April 15, 1993

Client No. 20368
Project No. 23813-1

**Addendum
Phase II Site Assessment and
Supplemental Soil-Gas Survey Workplan
Utility Trailer Manufacturing Company
City of Industry, California**

SITE PLAN
 Utility Trailer Manufacturing Company
 City of Industry, California

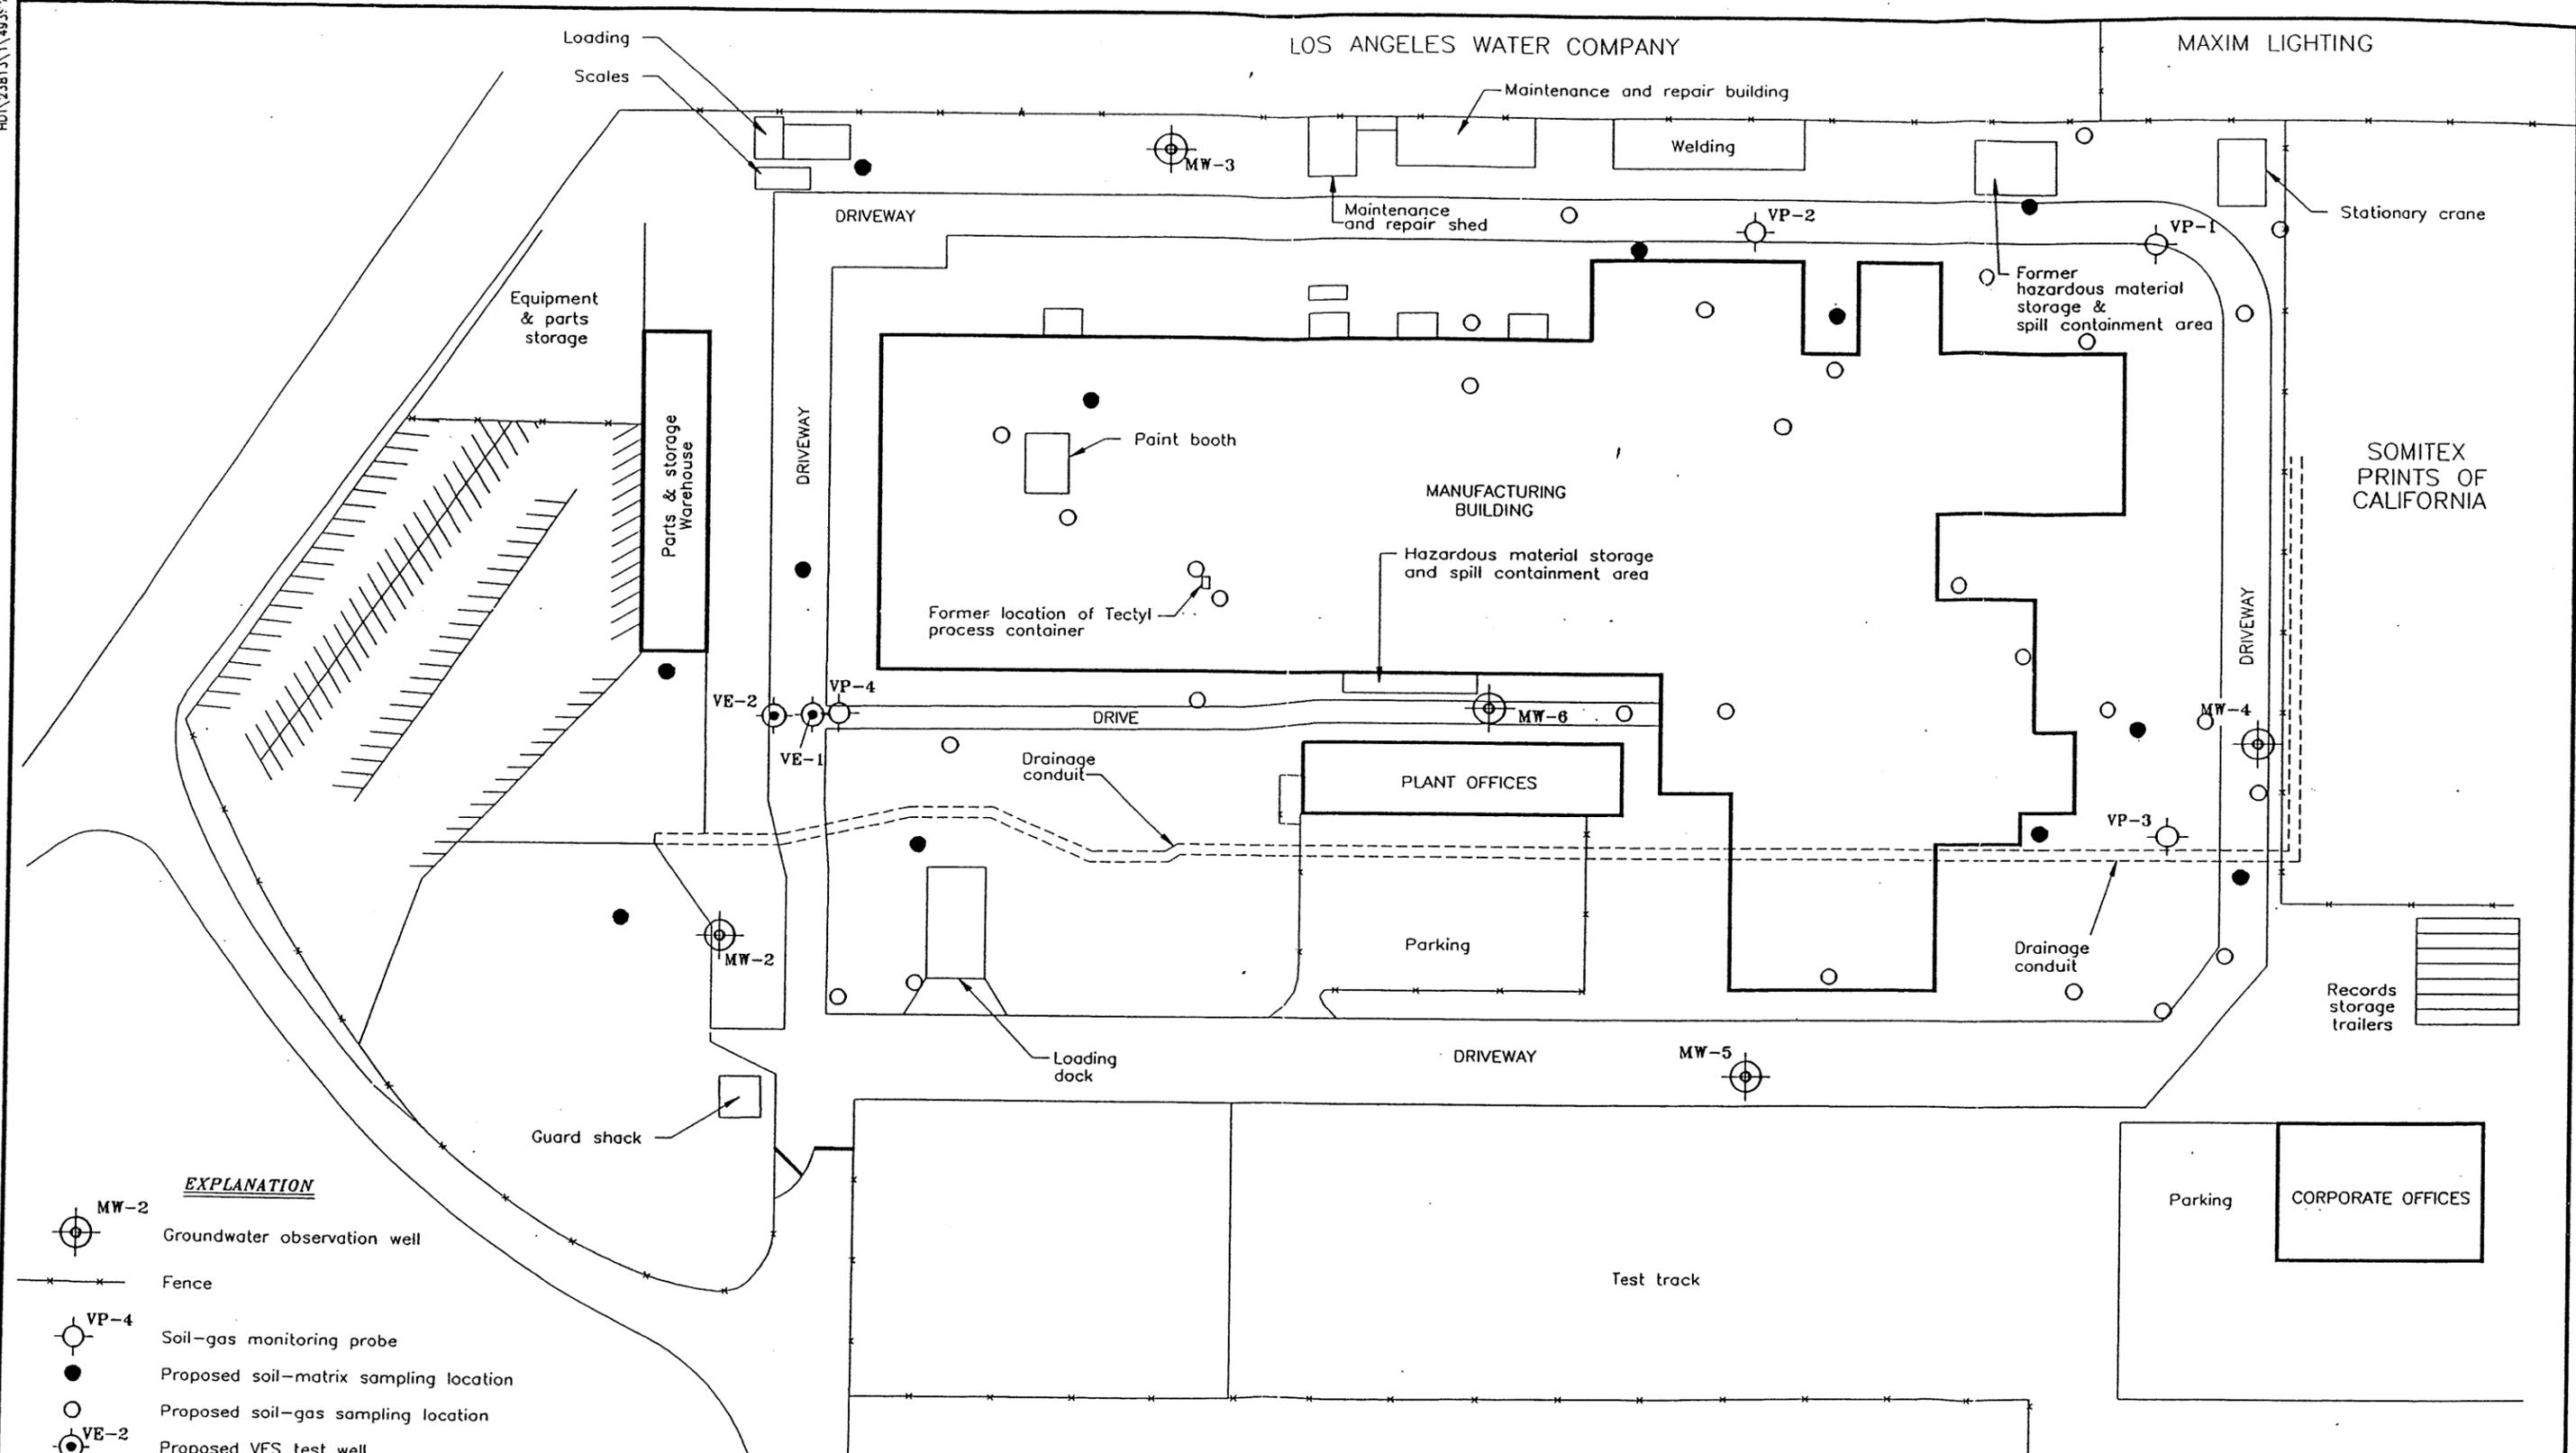
Plate 1 presents the revised locations for the supplemental soil-gas survey. In summary, a total of 30 locations will be sampled. At all locations, except the two locations at the former Tectyl process container, an attempt will be made to collect a sample at a depth of approximately 6 feet below ground surface (bgs). If the shallow sample indicates relatively high concentrations of the targeted compounds, an attempt will be made to collect a deeper sample at approximately 14 feet bgs. Attempts will be made to sample the two locations at the former Tectyl process container at depths of approximately 15 feet bgs, as required by the RWQCB in their letter dated December 24, 1992. Data collected during the initial soil-gas survey performed at the site in 1991 will be used to ascertain whether the concentrations appear relatively high in any particular area.

Locations that indicate relatively high concentrations of the targeted compounds may require additional lateral delineation. Lateral delineation will depend upon review of the initial soil-gas survey results.

Soil-matrix samples were collected and analyzed during the Phase I site assessment (VP-1 through VP-4) in areas that have been identified as having elevated concentrations of volatile organic compounds (VOC) in the soil-gas. These areas were identified in the initial soil gas survey. Eleven additional soil sampling locations are proposed to further assess VOC-impacted soil. The rationale for selecting these locations is as follows:

- Four locations in the area surrounding VP-4 were selected to further assess and quantify the elevated VOCs detected in the soil-gas. In addition, the two vapor extraction test wells will be installed in this area. Soil samples will be collected and analyzed from the borings for these two wells as described in HLA's previously submitted workplan.

- One location was selected in the area of the paint booth in the northern portion of the manufacturing building to provide soil matrix information and to determine whether elevated VOCs are present in the subsurface at this location.

- Three locations were selected in the area surrounding VP-2. Data from soil samples collected in these locations, in conjunction with data already collected during the installation of VP-1, will further assess and quantify the elevated VOCs detected in the soil-gas.

- Three locations were selected in the area surrounding VP-3 to further assess and quantify the elevated VOCs detected in the soil-gas.
